RAMP REPORT REGION 2 ADA 2026

Route 7 – Vine Street
Belfast

CR09021

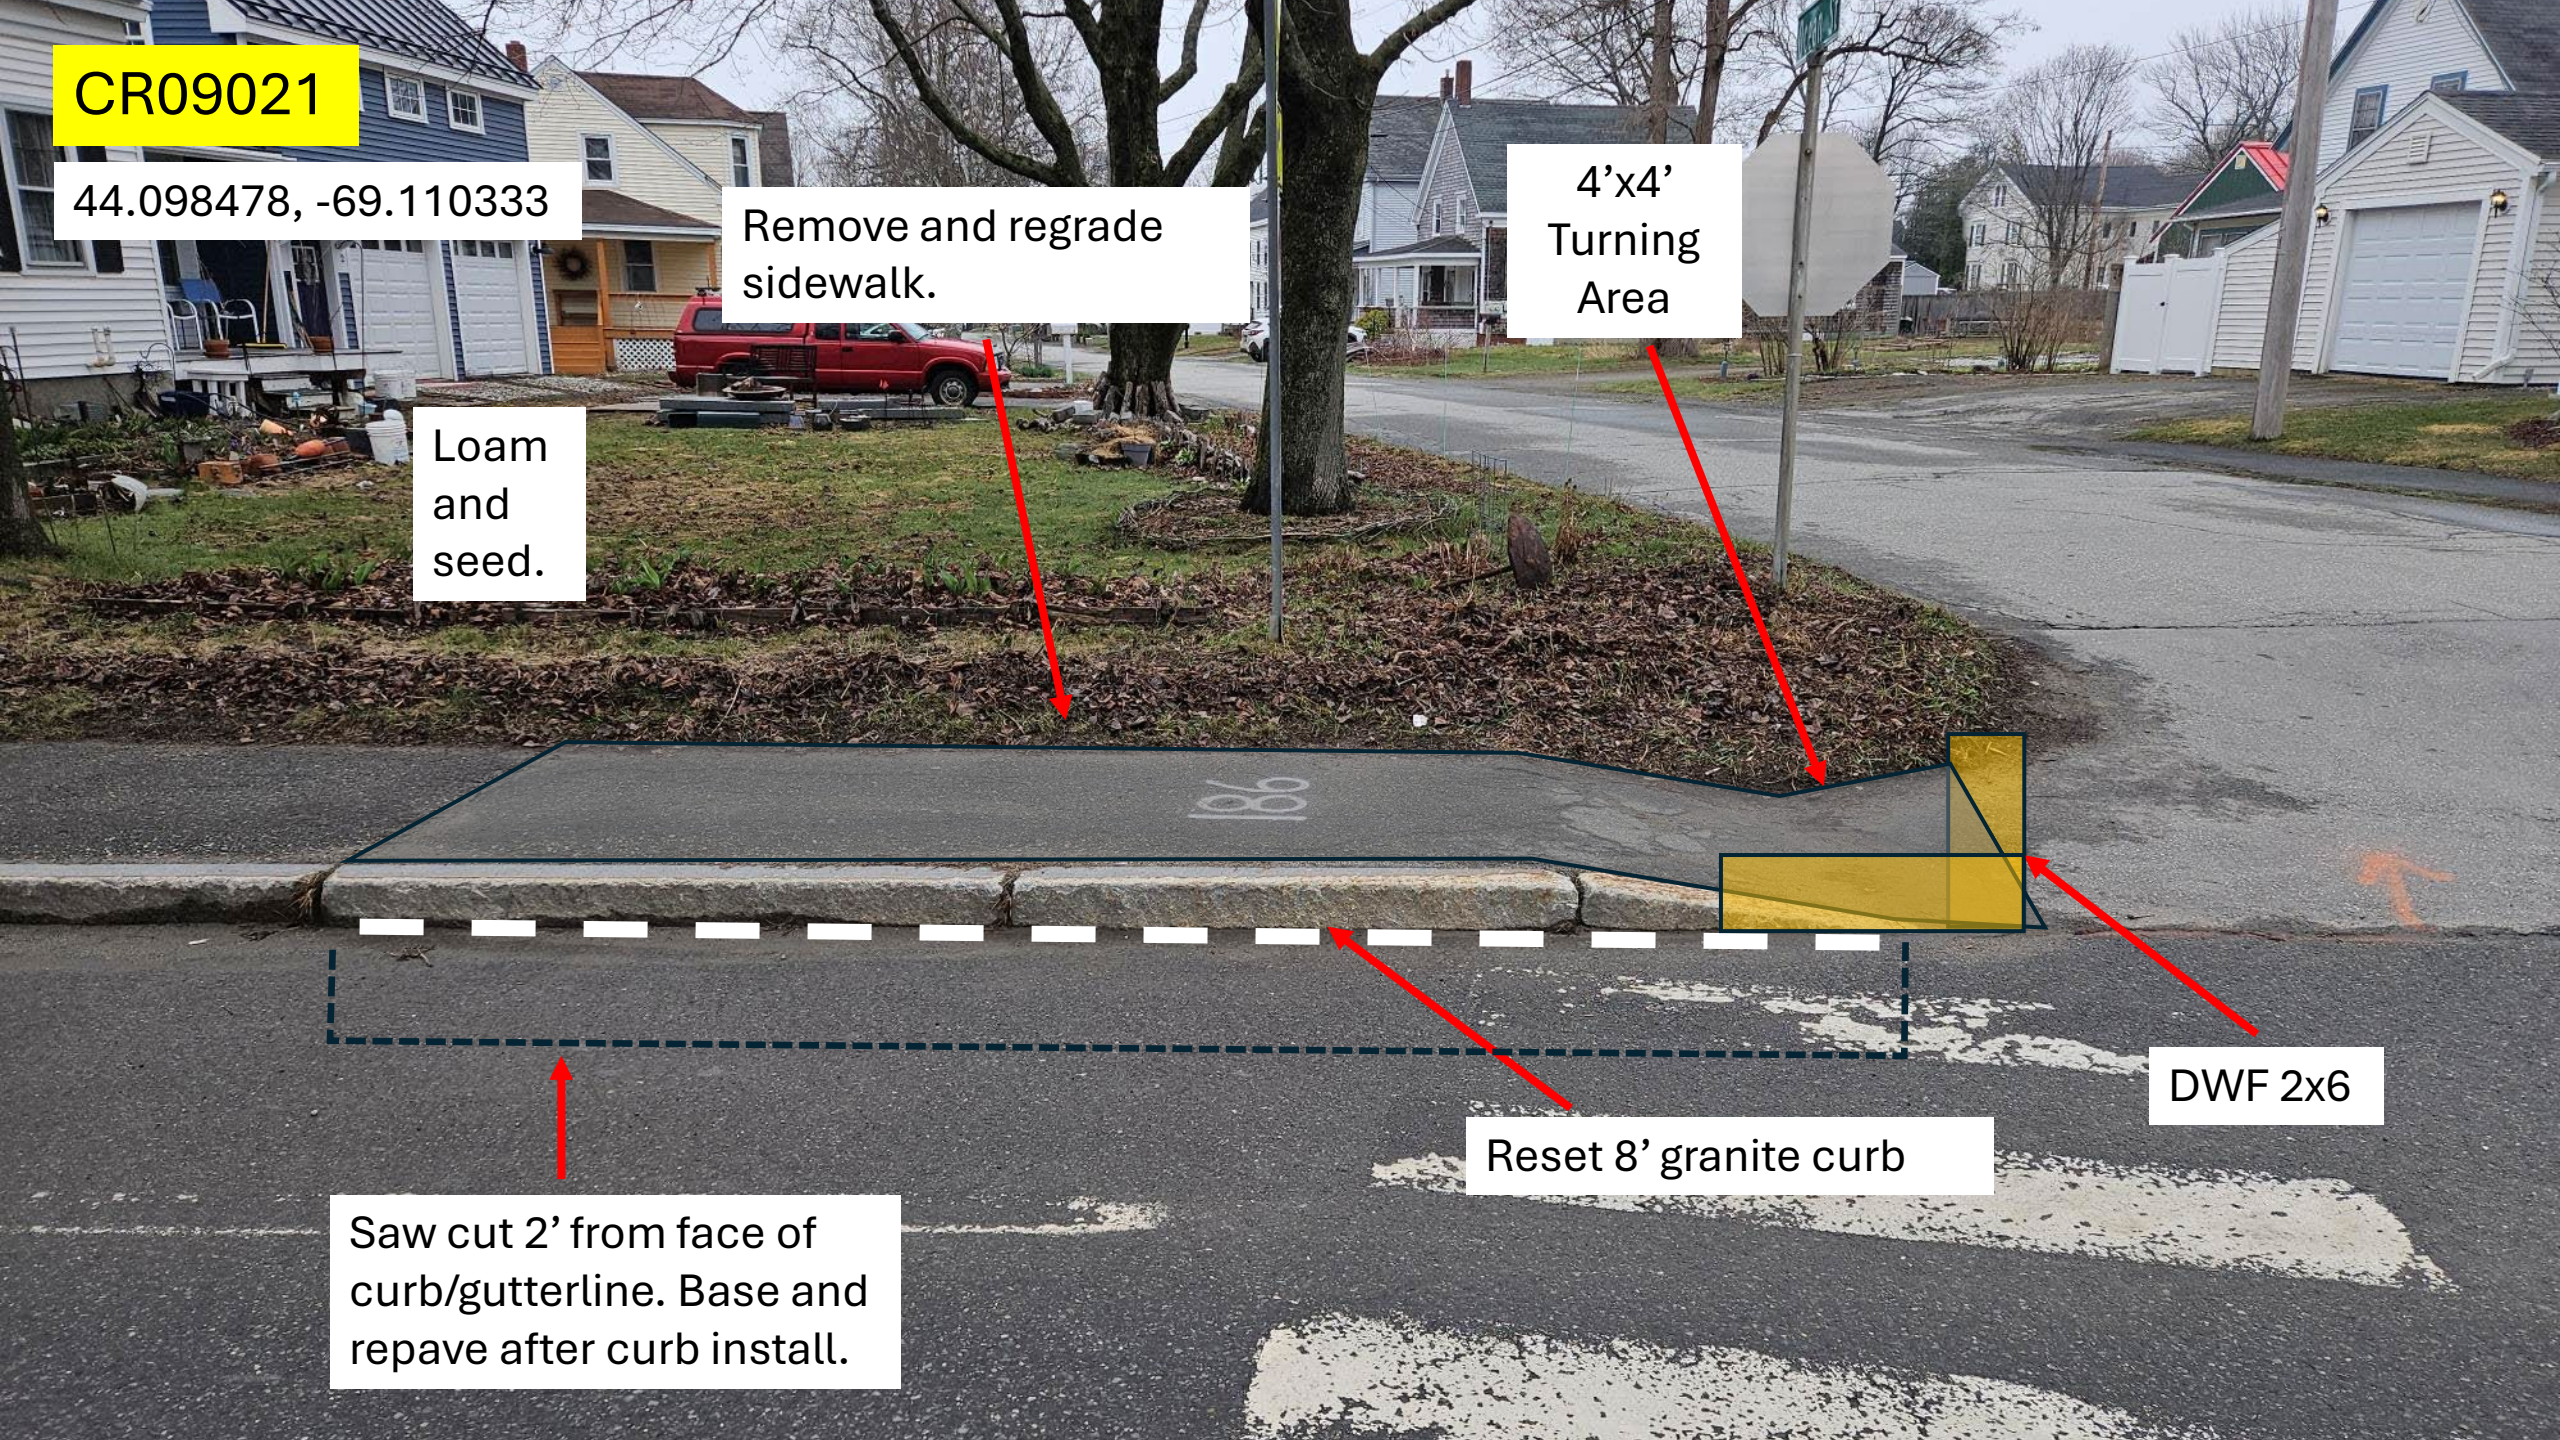
Remove and regrade sidewalk.

Loam and seed.

4'x4' Turning Area

DWF 2x6

Reset 8' granite curb

Saw cut 2' from face of curb/gutterline. Base and repave after curb install.

CR09022

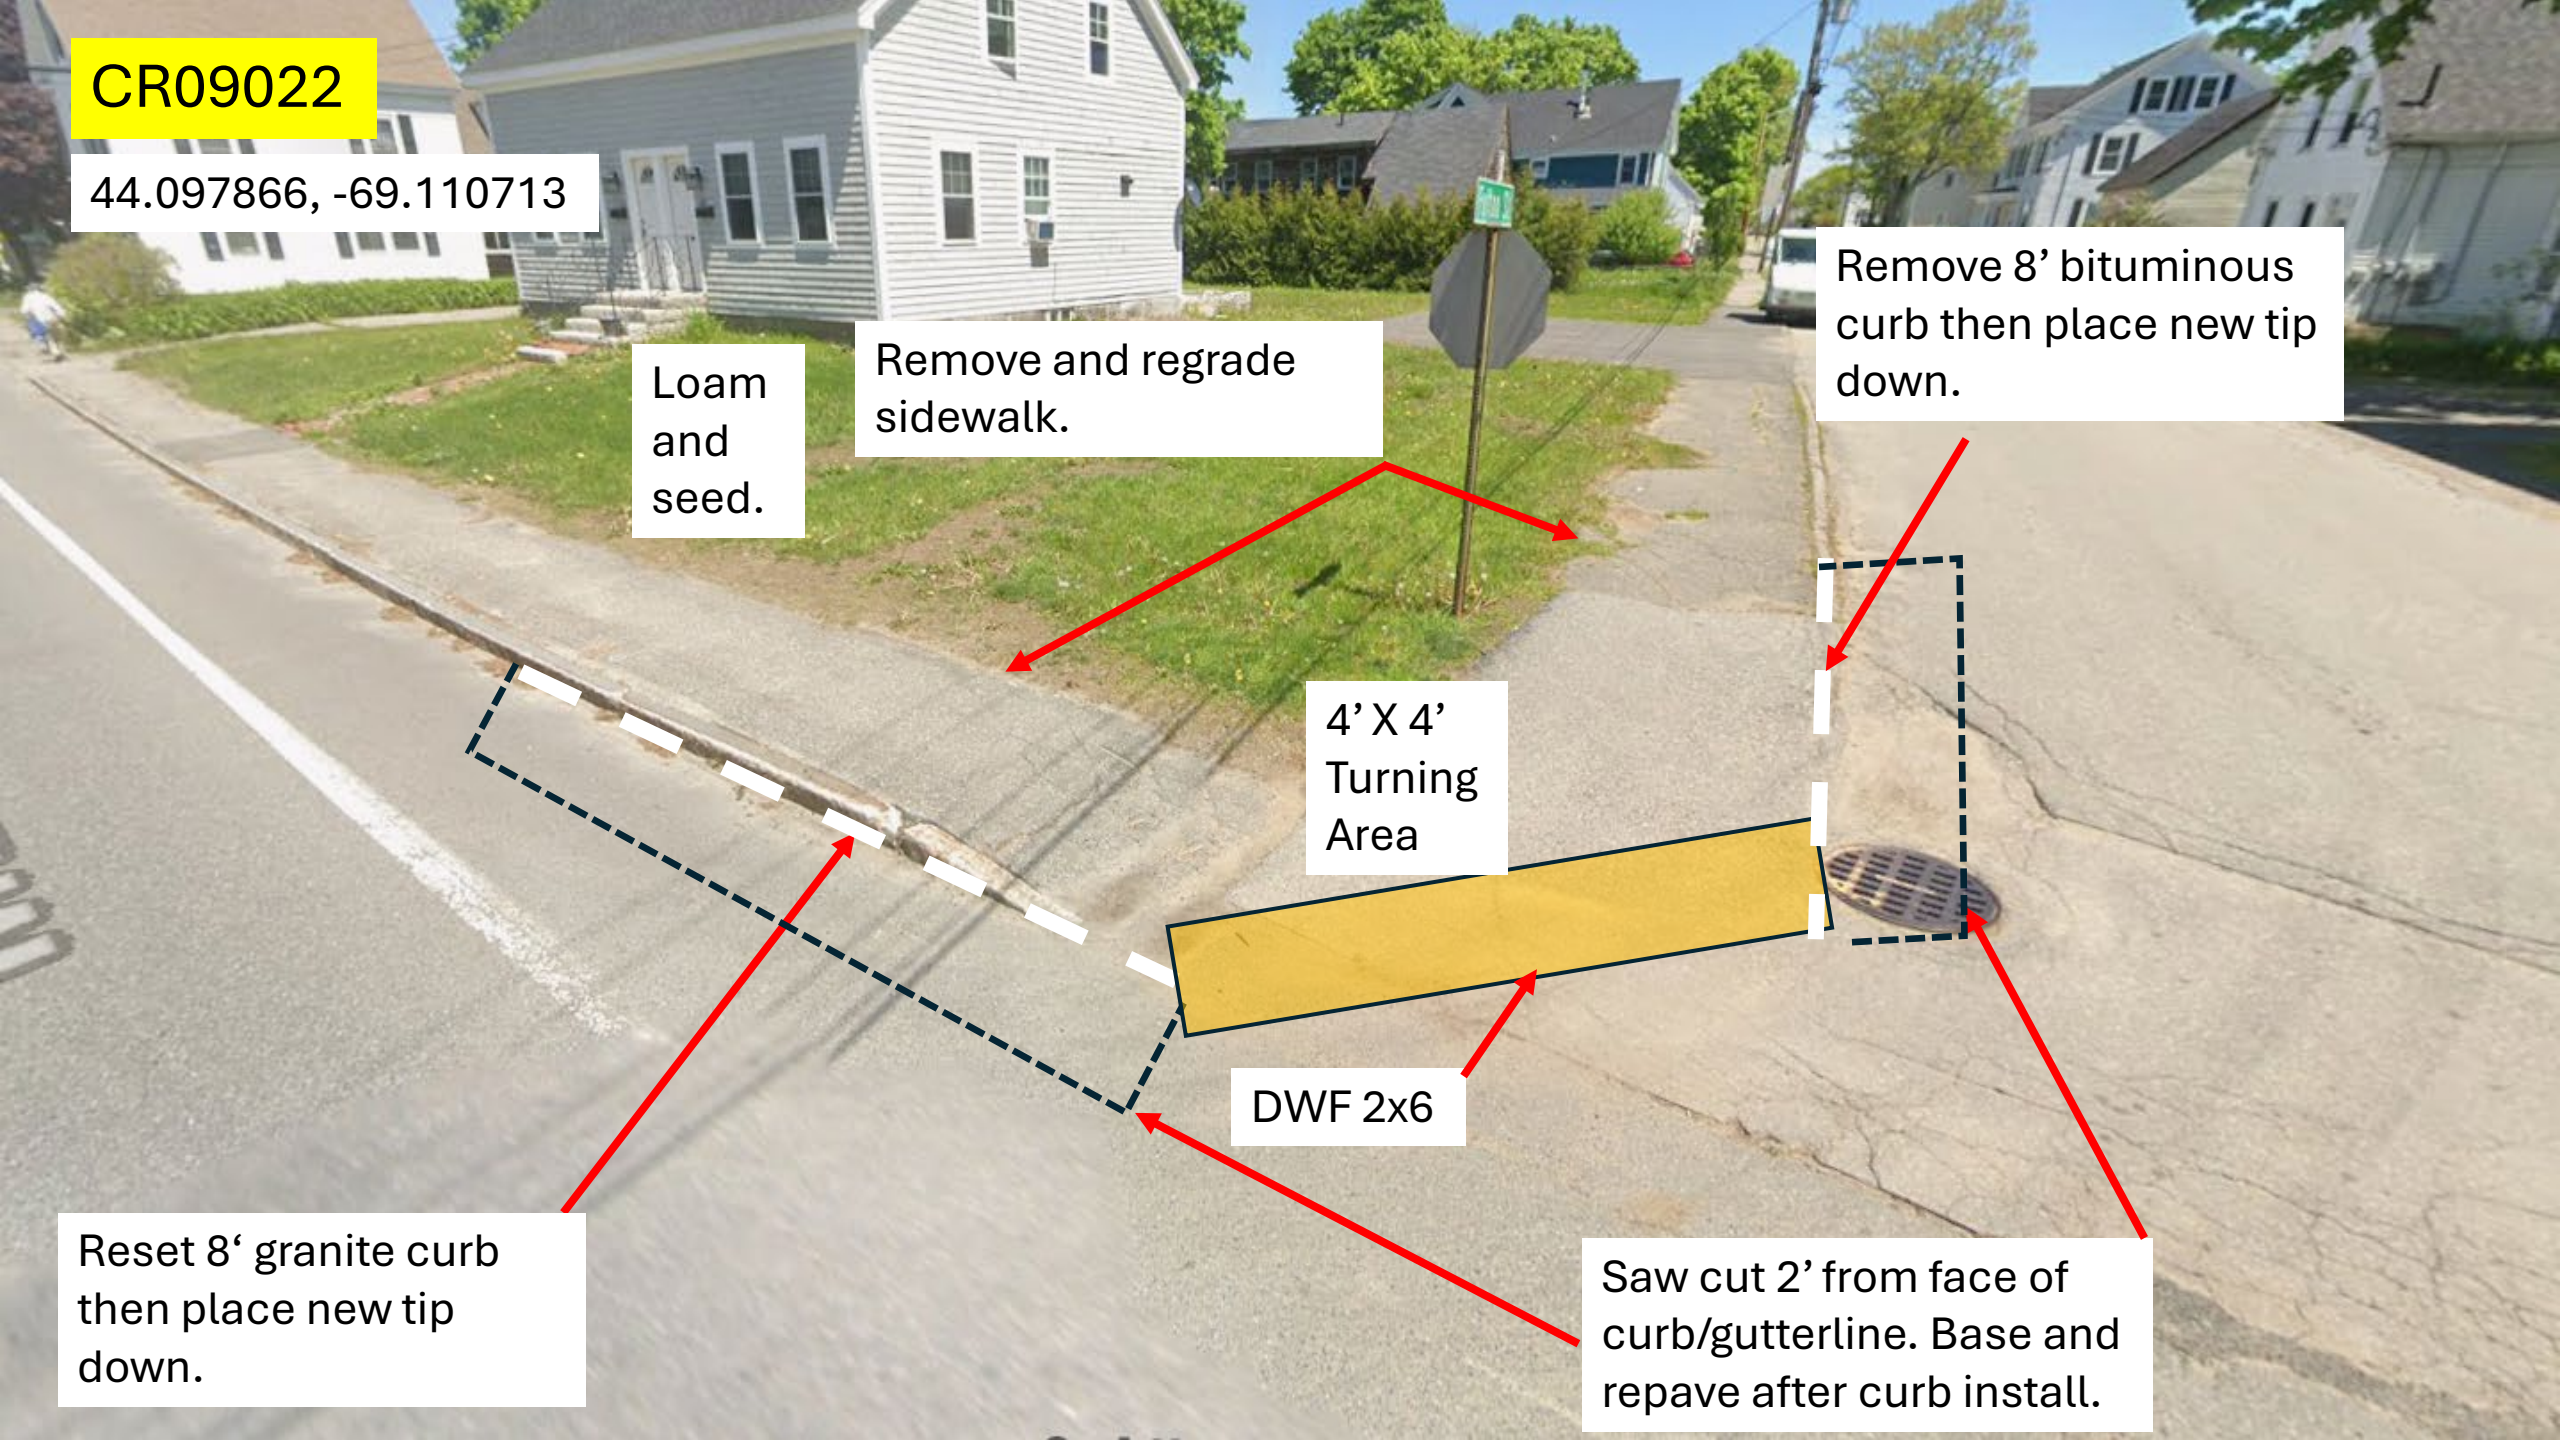
Loam
and
seed.

Remove and regrade
sidewalk.

Remove 8' bituminous
curb then place new tip
down.

4' X 4'
Turning
Area

DWF 2x6

Reset 8' granite curb
then place new tip
down.

Saw cut 2' from face of
curb/gutterline. Base and
repave after curb install.

CR09023

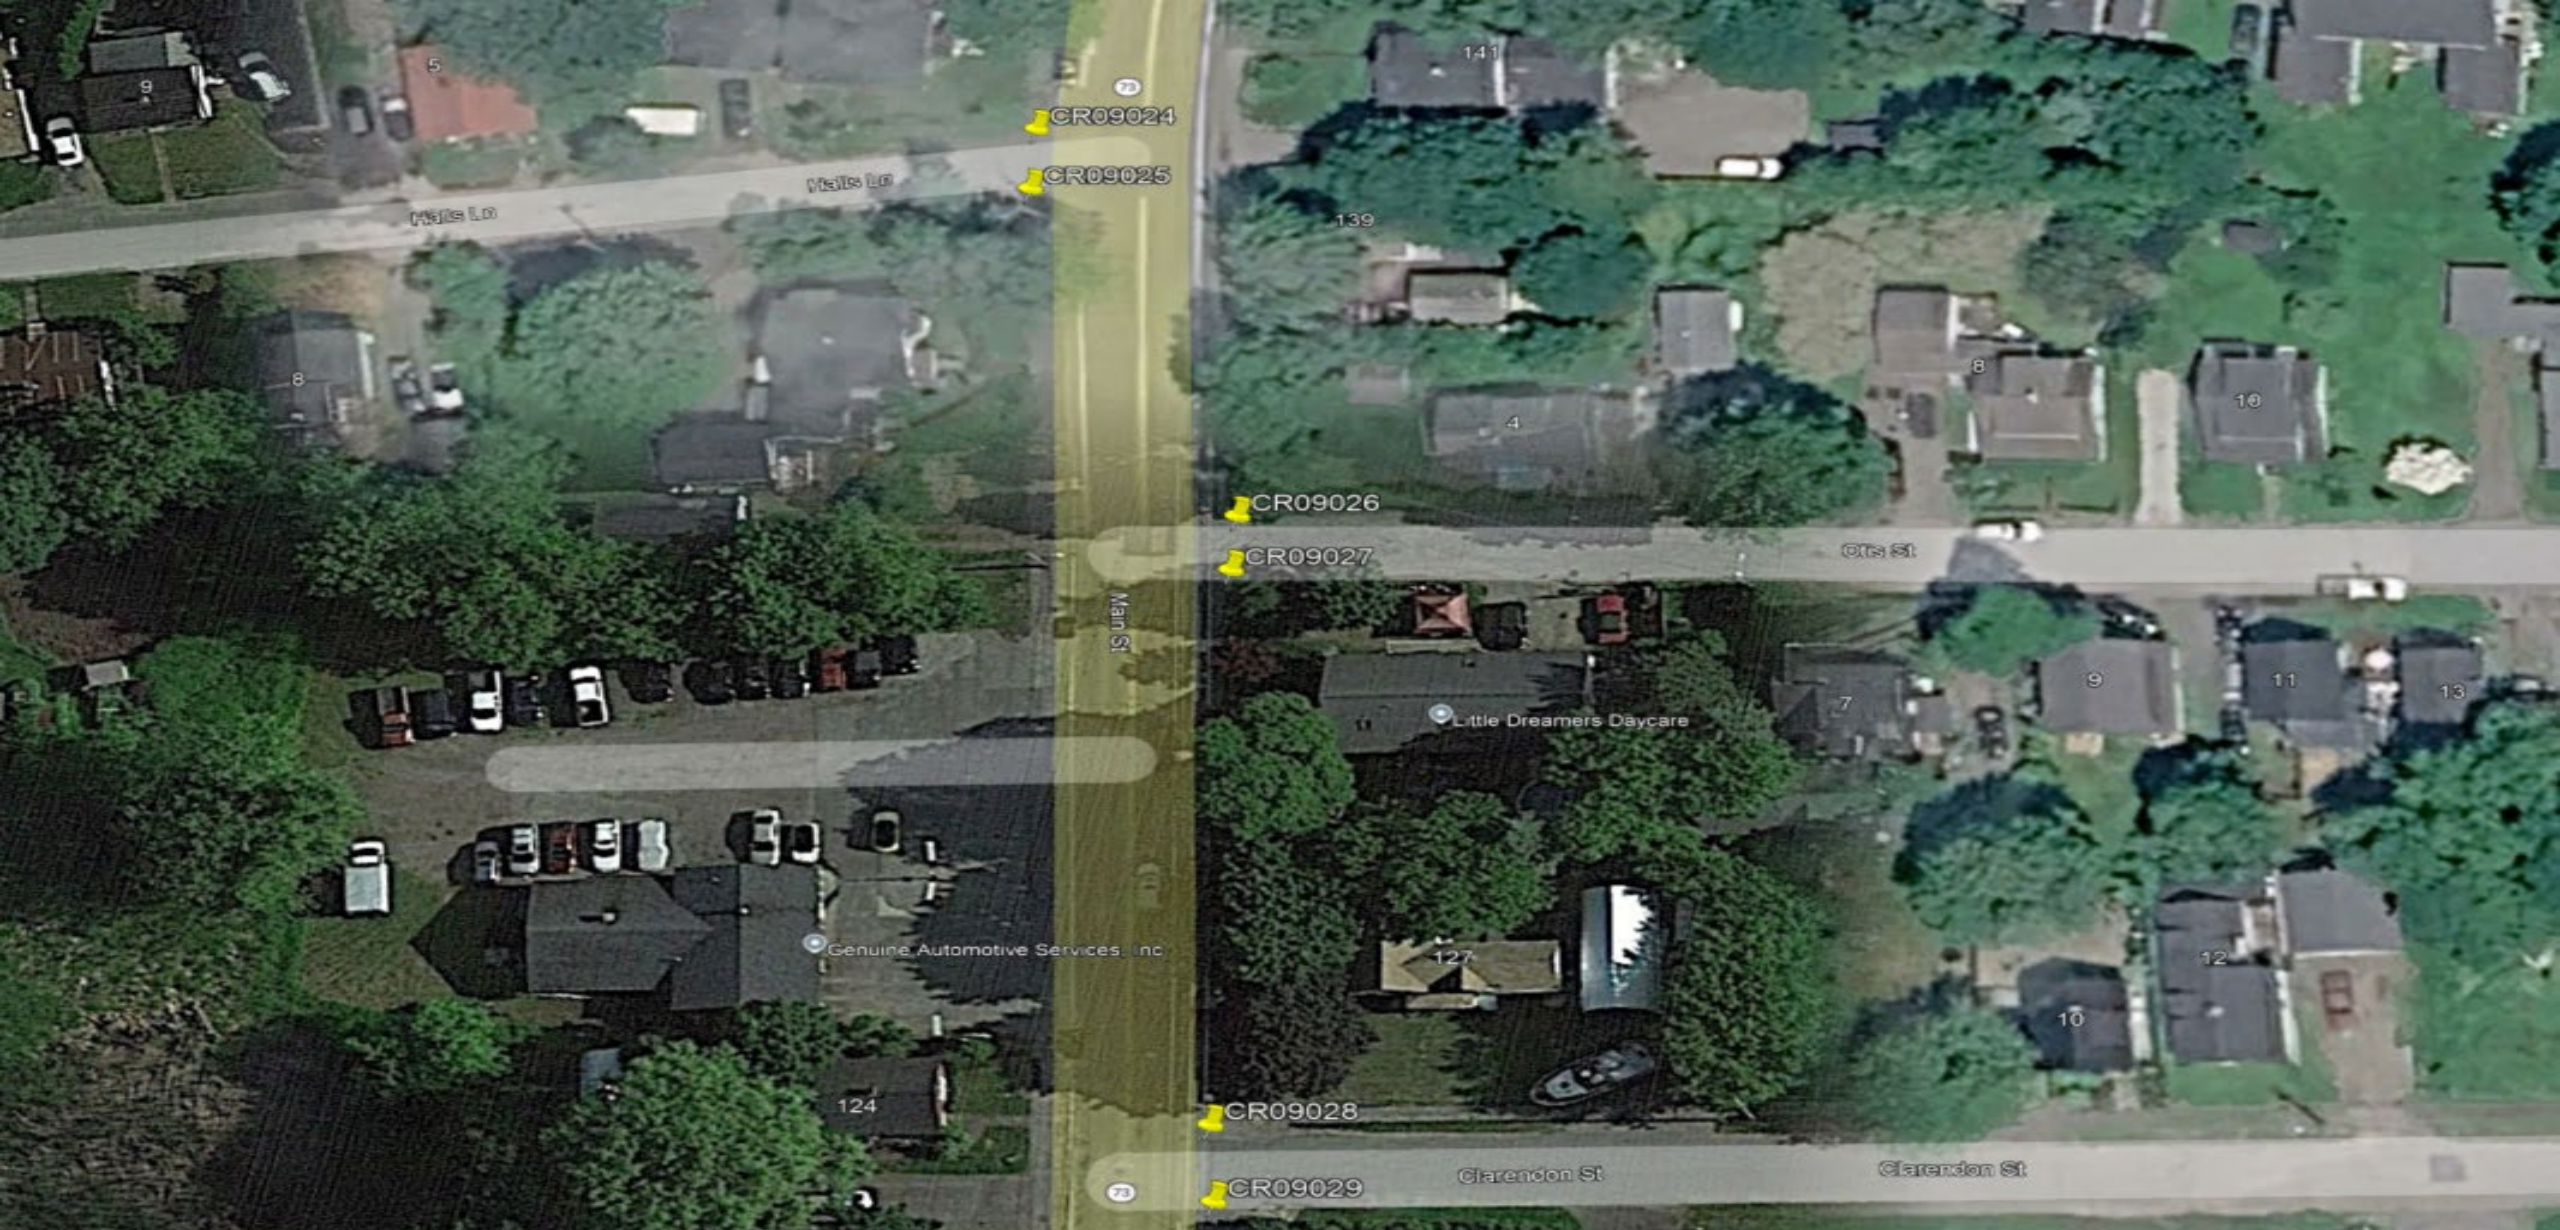
Loam
and
seed.

Remove and regrade
sidewalk.

Remove 8' bituminous
curb then place new tip
down.

DWF 2x4

Saw cut 2' from face of
curb/gutterline. Base and
repave after curb install.
